**Plan Commission – Special Meeting Agenda
Thursday, February 8, 2024
Village Hall, 65 Cedar Avenue**

DATE: February 1, 2024
TO: Chairman Craig Kressner and Members of the Plan Commission
FROM: Michael Strong, Village Administrator
RE: 0 Deep Lake Road – Starling Senior Apartments Development

Exhibit 1 – Complete Plan Submittal Set (Recent Rev. 1/16/2024)

Manhard CONSULTING
 LAKE VILLA SENIOR LOFTS
 VILLAGE OF LAKE VILLA, ILLINOIS
 TITLE SHEET AND LANDSCAPE SUMMARY
 SHEET
 L1 of L7
 LAC L101

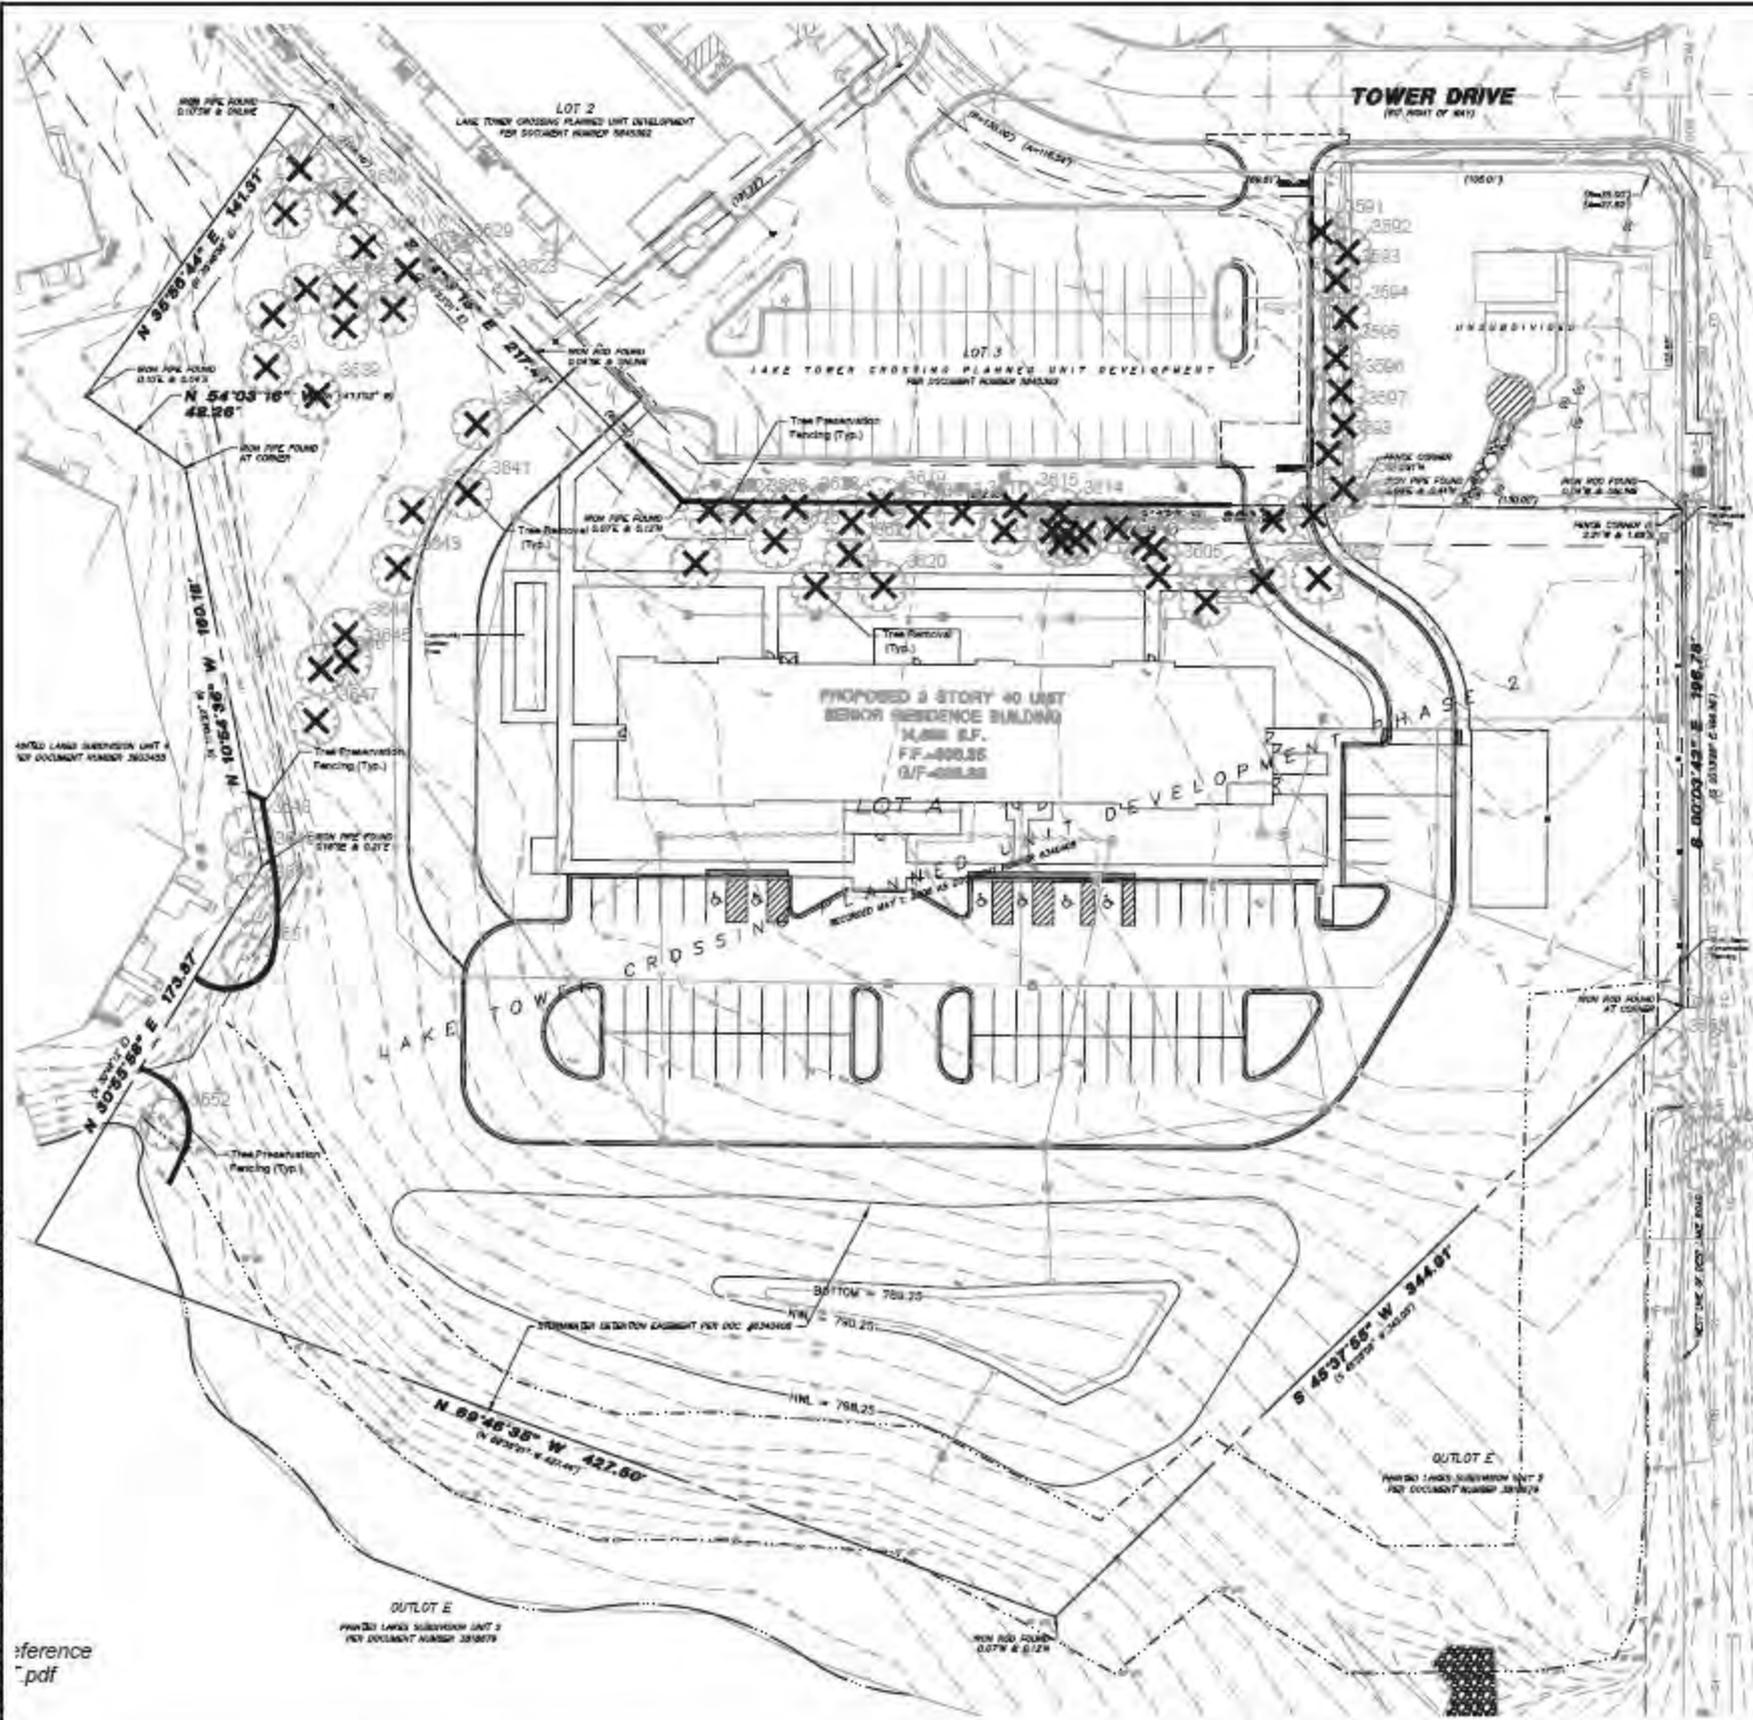
- The Village Planner noted that there are additional tree replacements needed for trees that will be removed along the access drive west of the water tower. The Developer's final landscape plan should include those required replacements, which shall be located east of the new sidewalk to provide screening to the Water Tower.
- The Developer has not submitted any plans for their proposed monument sign, elevations and details relative to signage shall be submitted to the Village Planner for review and approval prior to permits being issued for any signage.
